SERVICE TIPS

JULY 10, 1964

KRK 114 SCHEMATIC DIAGRAM CORRECTION

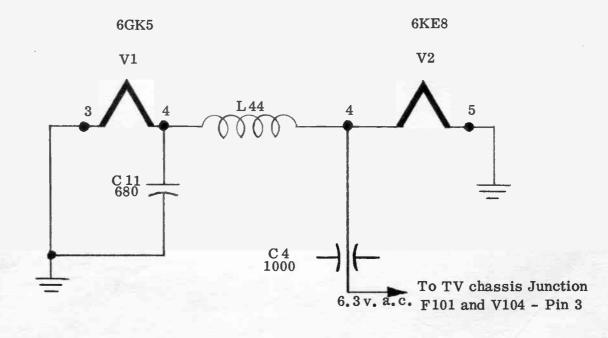
The heater wiring diagram and tube lineup for the KRK 114 schematic diagram on Page 5 of Service Data 1964 No. T5 should be corrected as reproduced below:
